# Access Compliance Report

## Public Rights-of-Way

Intersection ID: 18026	Main Street: E_INDEPENDENCE_BV	Cross Street: WALLACE_LN	Location: NE
ADA ID: 5C916157316A	Ramp Type: Perp	Initial Pass/Fail: Fail	Overall Compliance: No Severity Score: 13.75

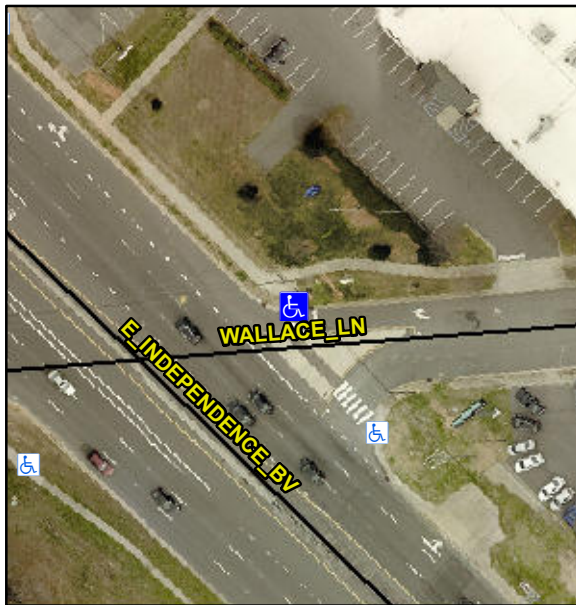
**Not Found, R304.2.2, R304.5.3**

Compliance	Description	Data	Compliance	Description	Data
N/A	Ramp Length (in)	157.0	No	Ramp Slope (%)	9.0
Yes	Ramp Width (in)	49.0	No	Ramp XSlope (%)	4.1
N/A	Flare Type LT	N/A	N/A	Flare Type RT	N/A
N/A	Flare Slope LT (%)	N/A	N/A	Flare Slope RT (%)	N/A
N/A	Flare Traversable LT?	N/A	N/A	Flare Traversable RT?	N/A
N/A	Landing Length (in)	N/A	N/A	DWS Provided?	N/A
N/A	Landing Width (in)	N/A	N/A	DWS Contrast?	N/A
N/A	Landing Slope (%)	N/A	N/A	DWS Length (in)	N/A
N/A	Landing X Slope (%)	N/A	N/A	DWS Full Width?	N/A
N/A	Landing Curb? (Y/N)	N/A	N/A	DWS Offset (in)	N/A
N/A	Shared Landing?	N/A			
N/A	Gutter Ponding?	N/A	N/A	Gutter Slope (%)	N/A
N/A	Gutter Lip Ht (in)	N/A	N/A	Gutter X Slope (%)	N/A
N/A	Painted X Walk1?	Yes	N/A	Painted X Walk2?	N/A
	X Walk 1 Direction	To SE		X Walk 2 Direction	N/A
N/A	X Walk 1 Width (in)	121.0	N/A	X Walk 2 Width (in)	N/A
	X Walk 1 Slope (%)	3.8		X Walk 2 Slope (%)	N/A
	X Walk 1 X Slope (%)	2.6		X Walk 2 X Slope (%)	N/A

**Remove & Replace Entire Ramp.**
